KEYSTONE XL PIPELINE PROJECT

0442-SD-P4-514.5-514.9-1

KEYSTONE XL PIPELINE PROJECT PIPELINE ROUTE VARIATION FORM			
1	VARIATION TYPE: Refinement: <input type="text"/> Reroute: <input checked="" type="checkbox"/> Footprint: <input type="text"/> Design: <input type="text"/> Centerline: <input checked="" type="checkbox"/> Pump Station: <input type="text"/> Valve Site: <input type="text"/> CAR: <input type="text"/>		
2	LOCATION: Sketch: <input type="text" value="Attached"/> Pictures: <input type="text" value="N/A"/> State: <input type="text" value="SD"/> County: <input type="text" value="Jones"/> Quad Map: <input type="text" value="N/A"/> Township: <input type="text" value="001S"/> Range: <input type="text" value="029E"/> Aerial Map: <input type="text" value="See attached map sheet"/> Section: <input type="text" value="36"/> Centerline: <input type="text" value="6/11/2013"/> MP: <input type="text" value="514.54"/> to <input type="text" value="514.94"/>

KEYSTONE XL PROJECT
PROPOSED ROUTE VARIATION

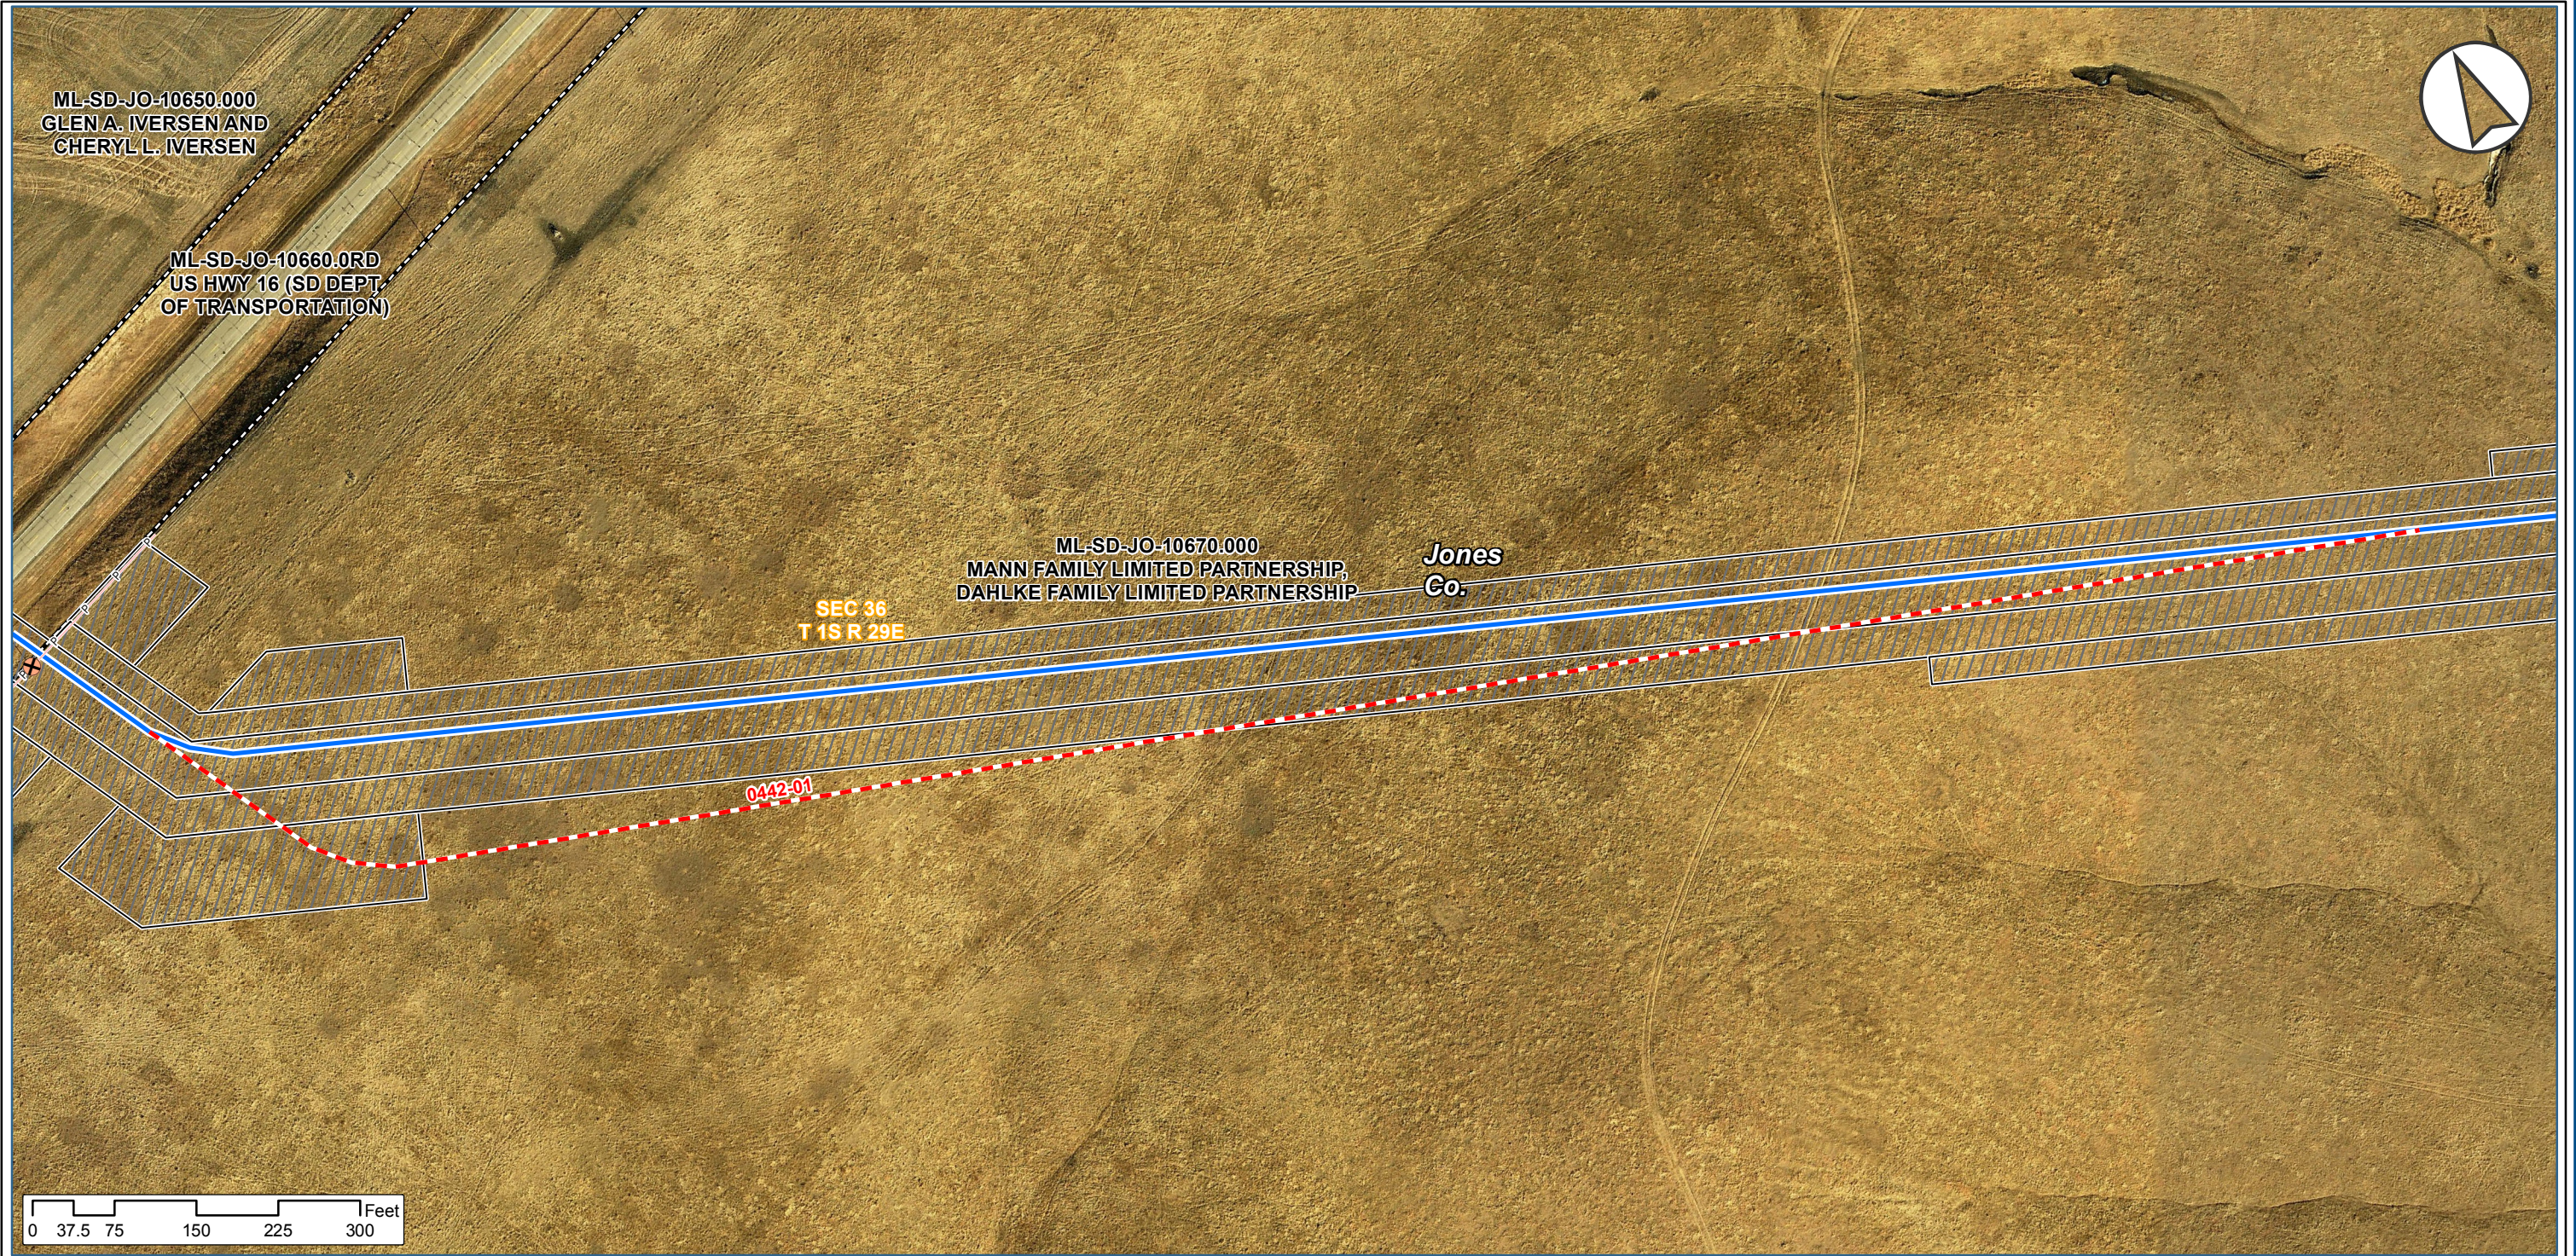
3	REASON FOR ROUTE VARIATION (Please include reason for route variation): The primary reason for this CL reroute is to shift bend further away from waterline (Oglala Sioux Rural Water Supply System) located south of HWY16 crossing per 60% CPMS design review (Item #74 in action Item list) and 90% alignment sheet review. This shift will allow for a better bore at this location. This reroute is requested by Engineering and has been field verified by civil survey.		
	DETAIL ROUTE VARIATION (Please describe route variation in detail): The proposed reroute begins at ~MP 514.5 and extends for ~182 feet in the same direction/straight line as the current CL, thus shifting the CL away from U.S Hwy 16/waterline. The proposed reroute, then turns east towards the current CL. It will continue in this east-southeast direction for ~1960 ft. before it reconnects with the current CL near MP 514.9		
	ADDITIONAL IMPACTS (Please include any additional impacts which may affect cost; crossings, induction bends, etc.): The proposed route variation falls within the current environmental surveyed corridor, so no additional costs associated with surveys will be incurred.
